St Marys Intermodal Modification 1

Rail refurbishment works package

State Significant Development Modification Assessment
(SSD 7308 MOD 1)

Published by the NSW Department of Planning, Industry and Environment

Figure 5 | Rail refurbishment works engineering drawings – Sheet 01 of 05 (Source: Applicant's Modification Report)

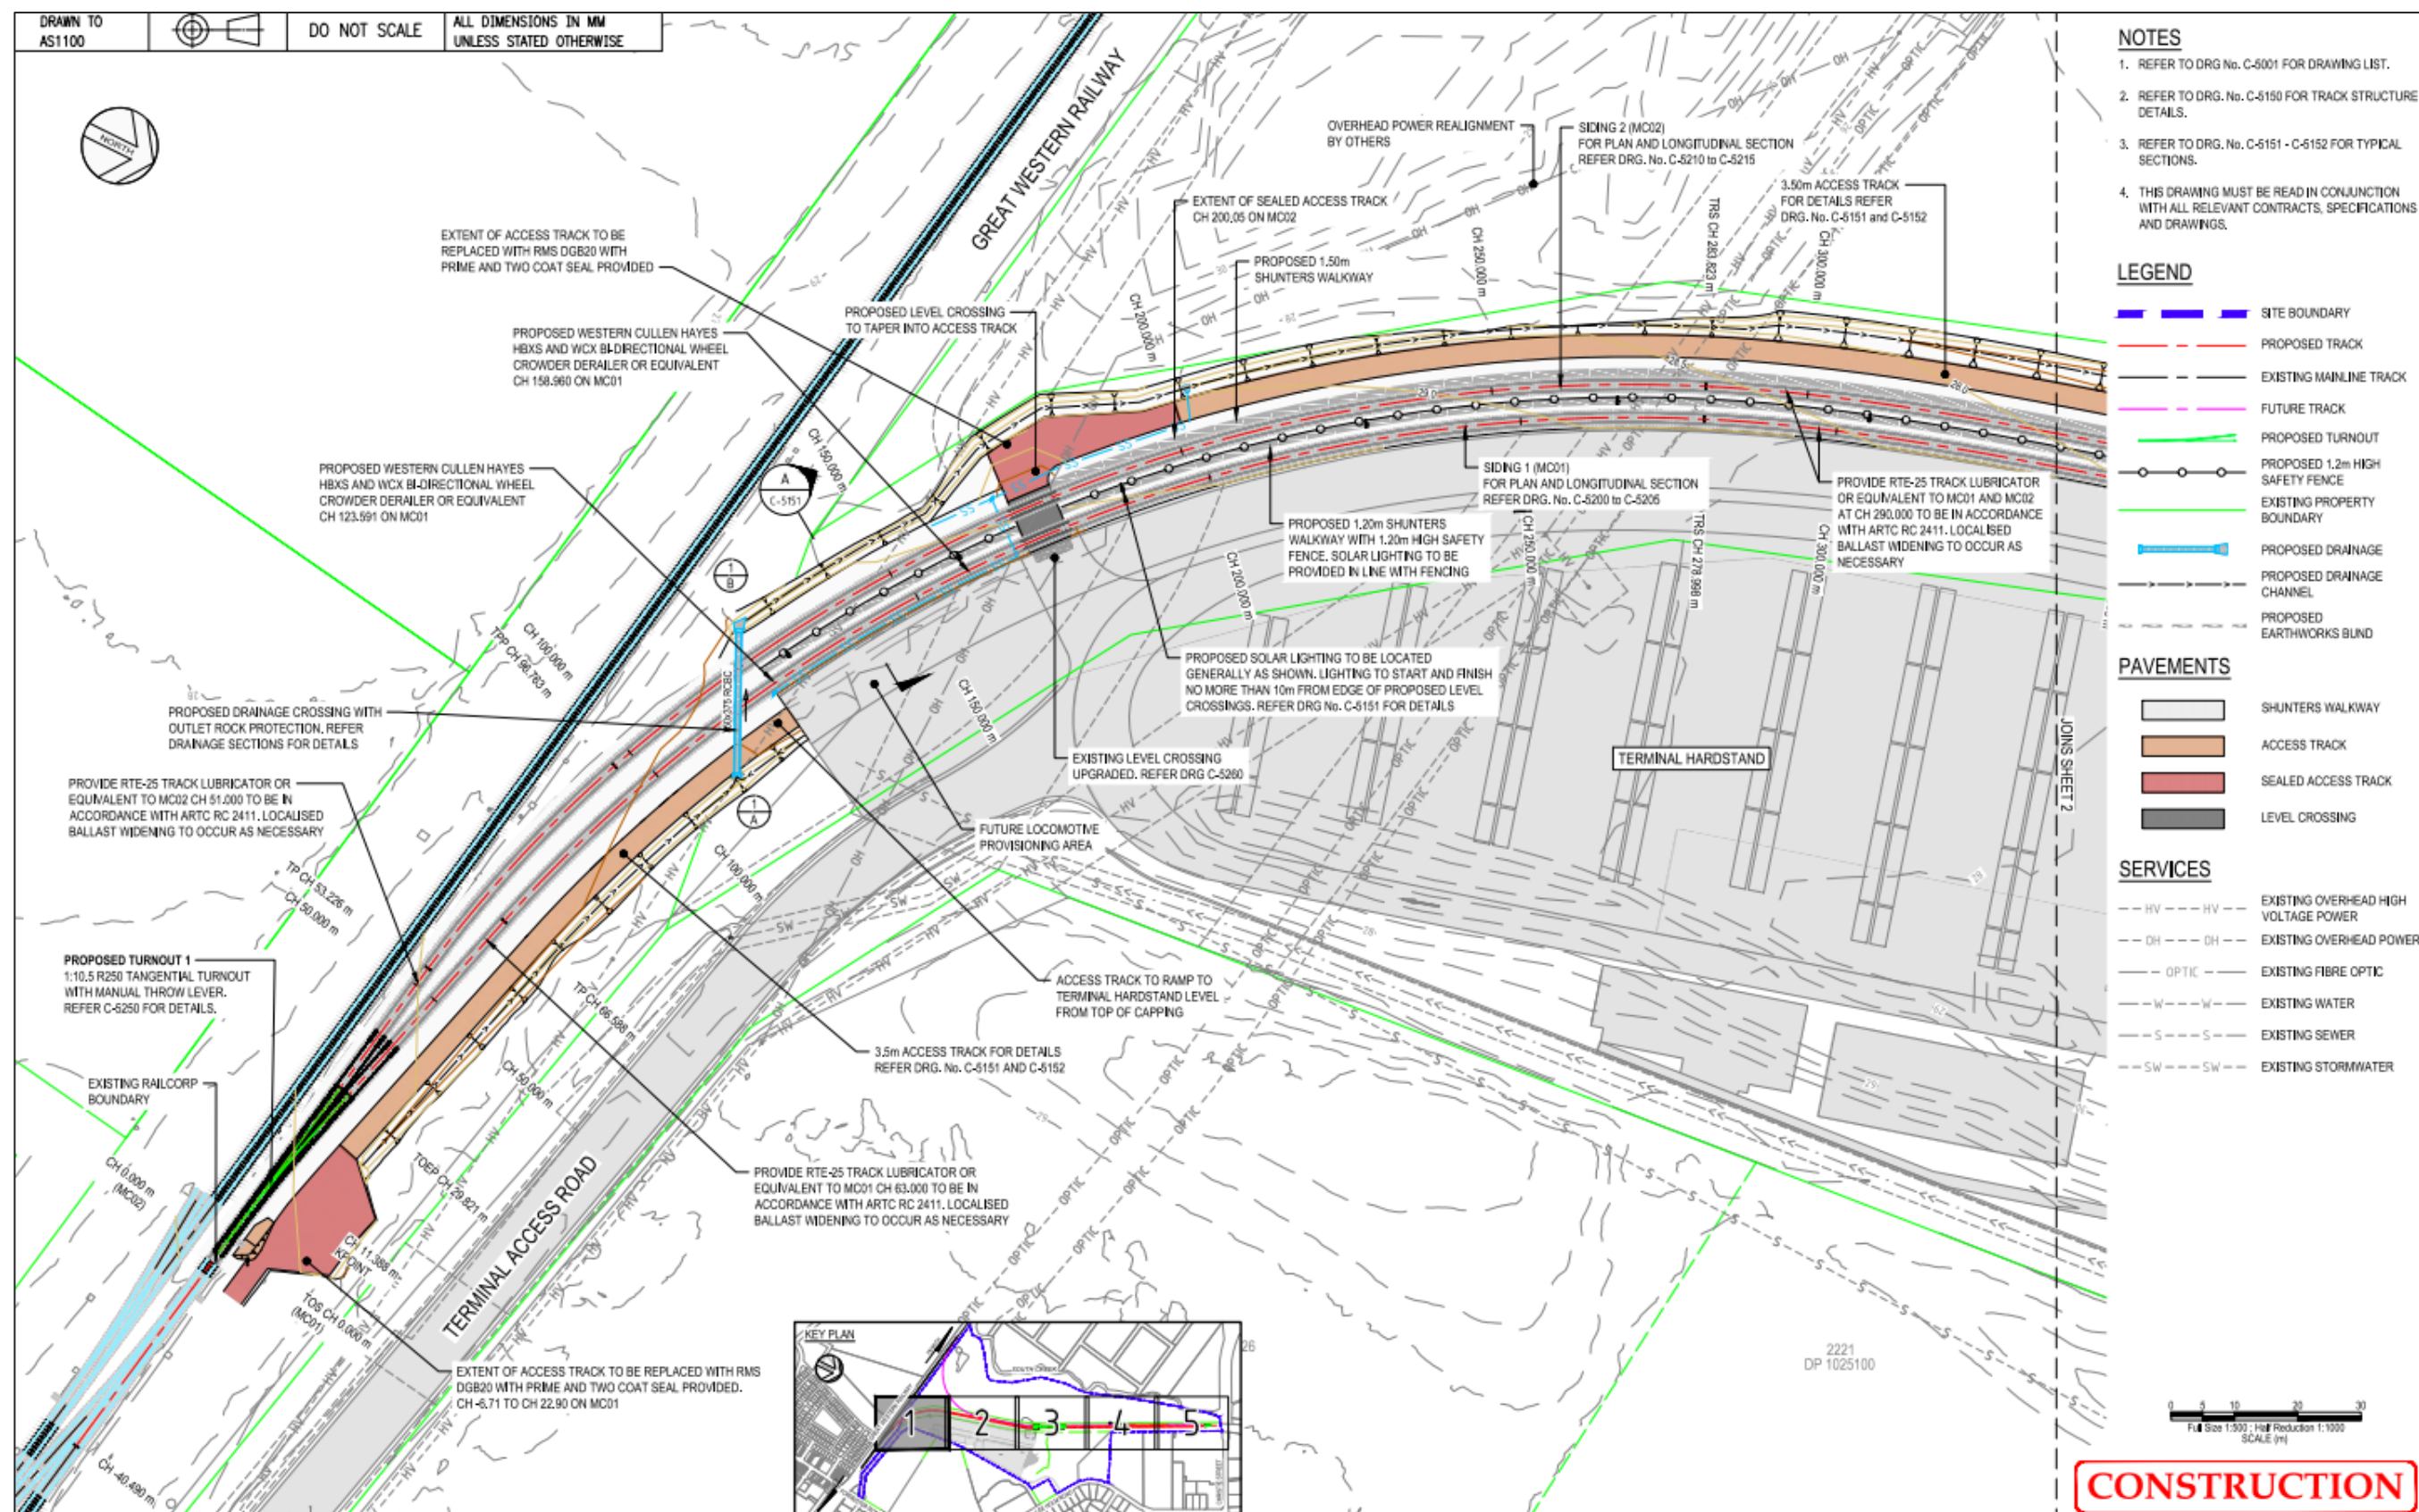
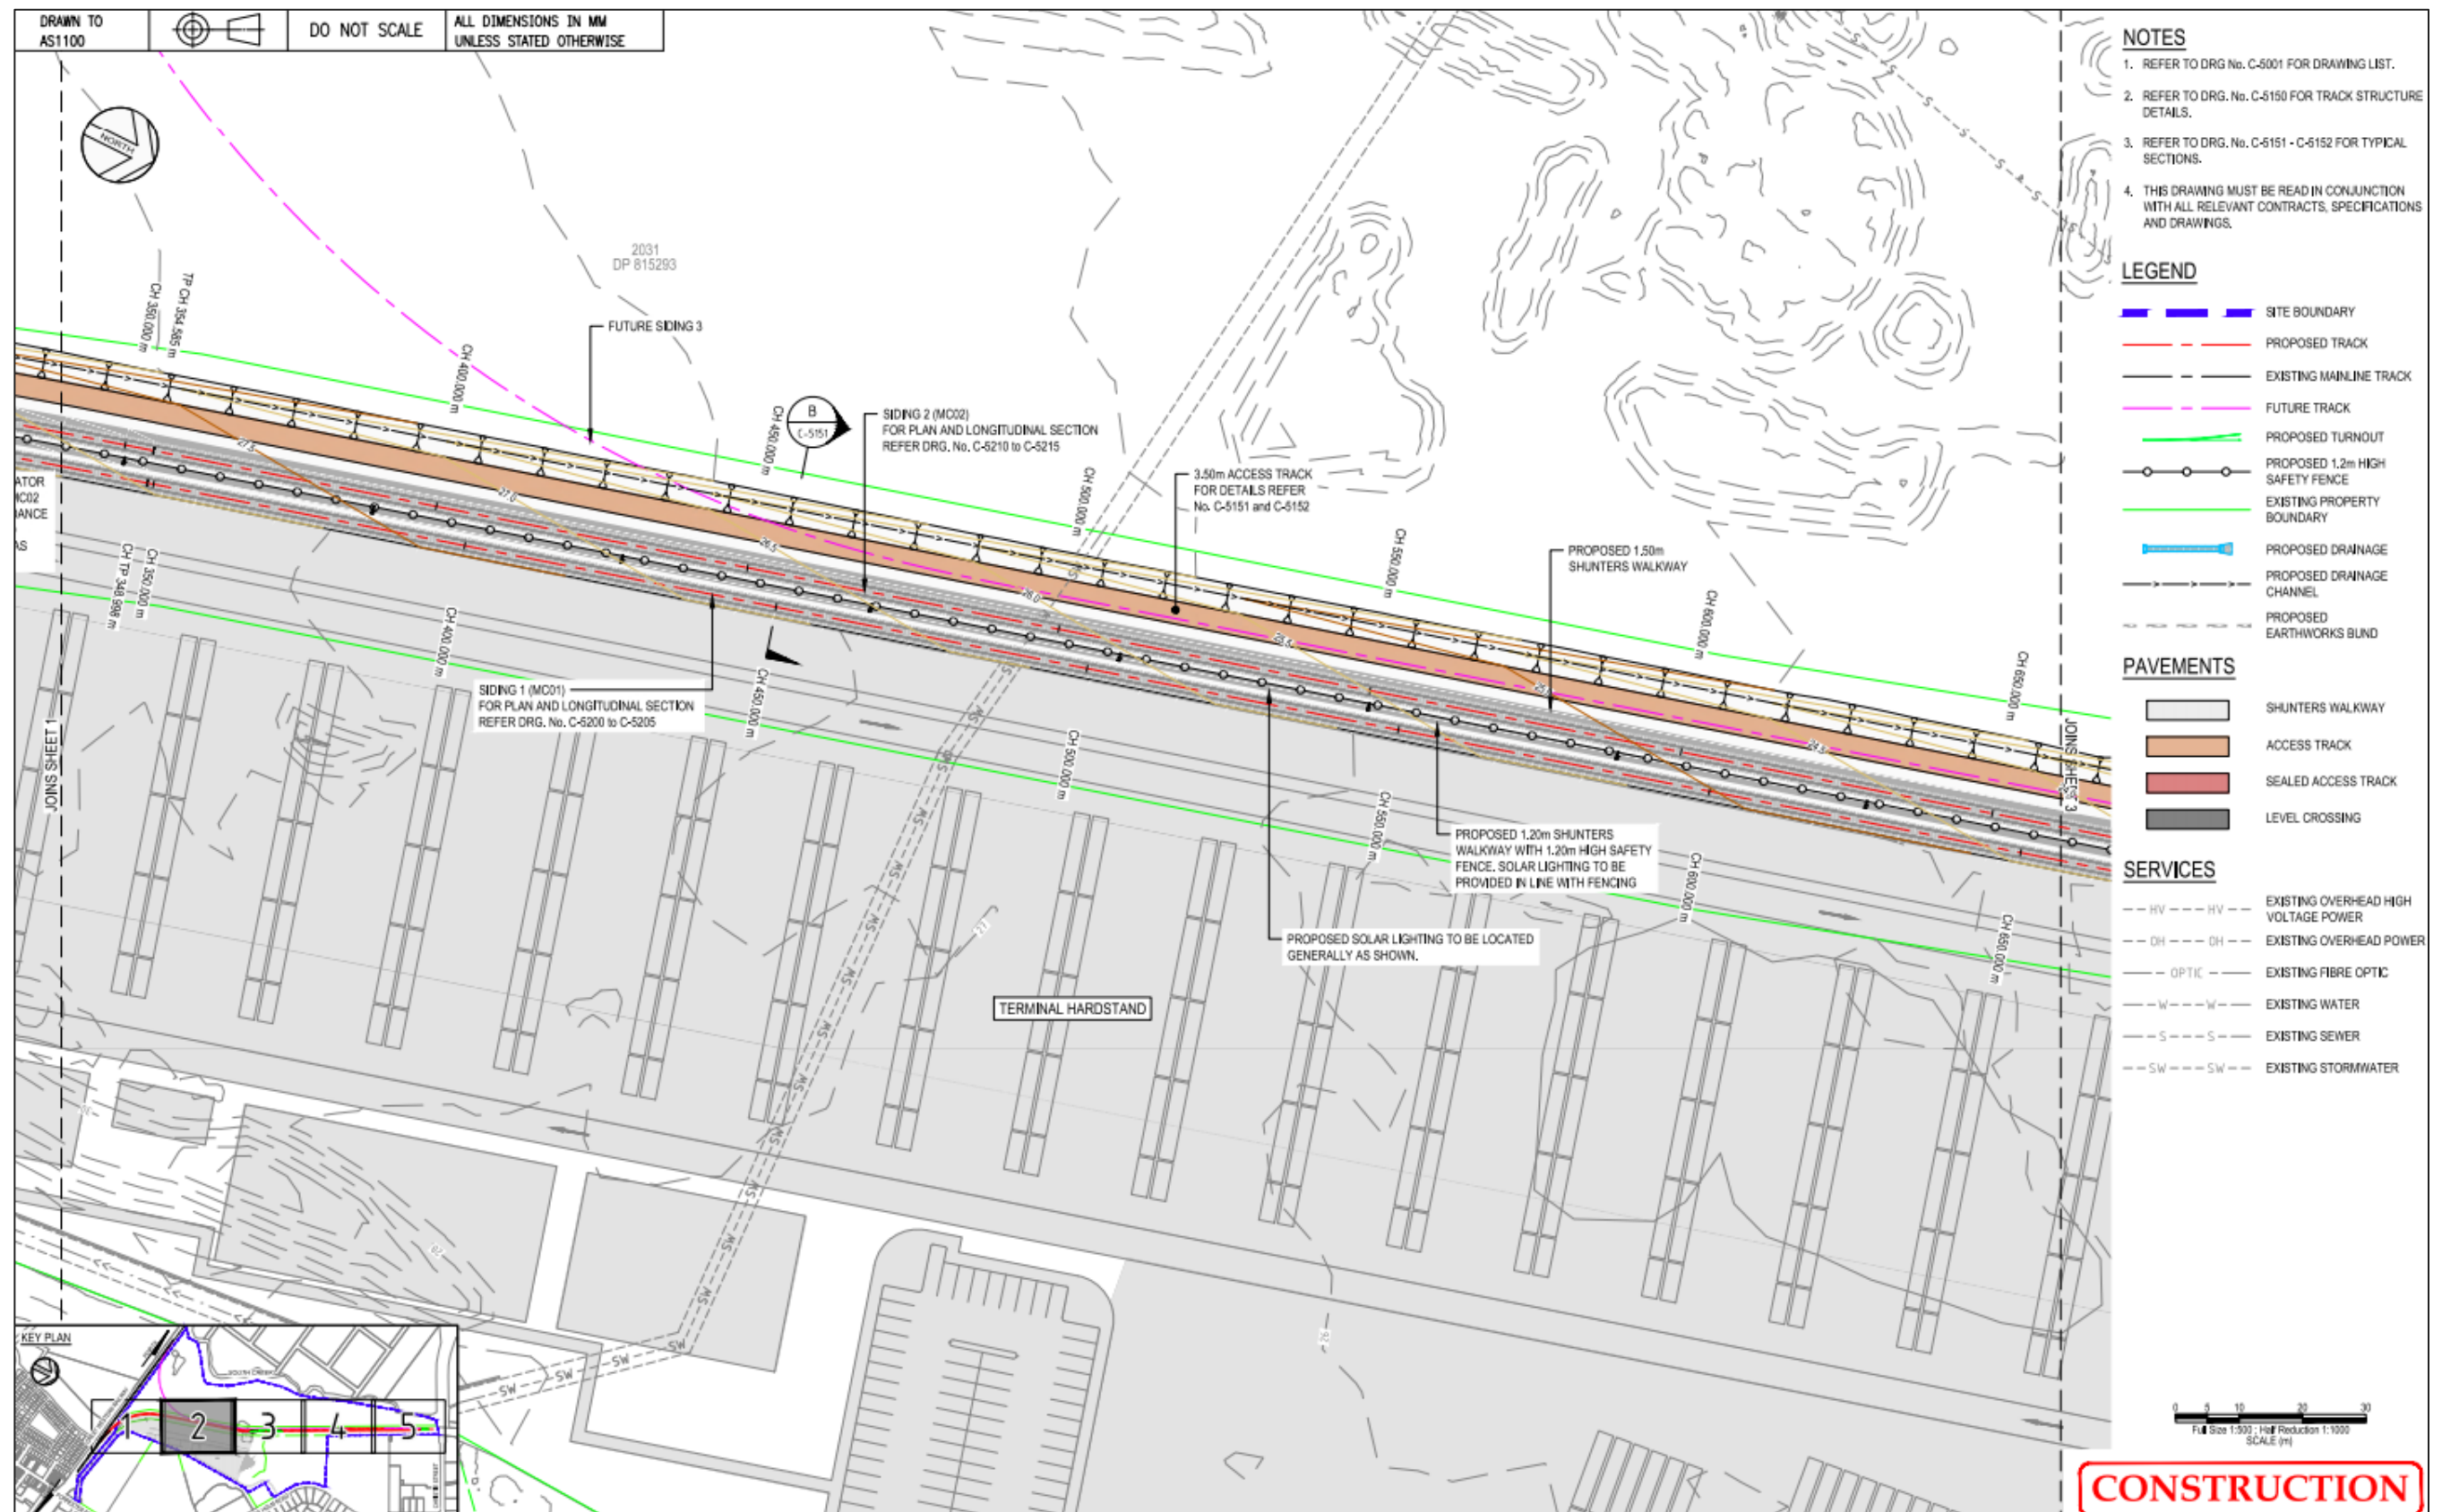
The proposal seeks to construct a 3.5 m wide one-way access track adjacent to the rail sidings and upgrade two existing level crossings (**Figure 5** to **Figure 9**). The access track would utilise an existing gravel access track that traverses Little Creek, to the immediate west of rail siding 2. The access track is proposed to run the full length of the rail sidings to allow light vehicles to transport locomotive drivers, enable access for maintenance works and allow track inspections during operation of the development.

As part of its submission on the modification application, Council requested a flood safety assessment be undertaken for the section of access track that traverses Little Creek, to assess flood velocity and depth for the safe access of vehicles, including possible warning signage, depth markers and potential upgrades to the pipe culvert to achieve flood safe access. As part of the RtS, the Applicant advised that the low point in the access track is subject to high hazard flood conditions during the 1% AEP event during both existing and post-developed peak-flow scenarios. To manage potential flooding impacts, the Applicant proposes to implement flood warning signage at the low point across Little Creek, enforce conditions for use of the access track in the Emergency Management Plan for the development, and restrict use of the track during flooding events. The Applicant also considered that upgrading the pipe culvert crossing Little Creek is not considered appropriate, as this would require raising the access track which has the potential to cause additional flooding impacts. The Department considers this approach to be acceptable.

Further, EESG recommended that an Emergency Management Plan be prepared for the development, to evacuate workers and users of the rail works area during a flood event. EESG also recommended the Applicant consult State Emergency Services during preparation of the plan, as the site is partially within the Hawkesbury-Nepean Regional flood extent. In response to advice provided by EESG, the Applicant advised that a site-specific Flood Management Plan would be implemented during operation of the development and would be maintained by the operator of the site.
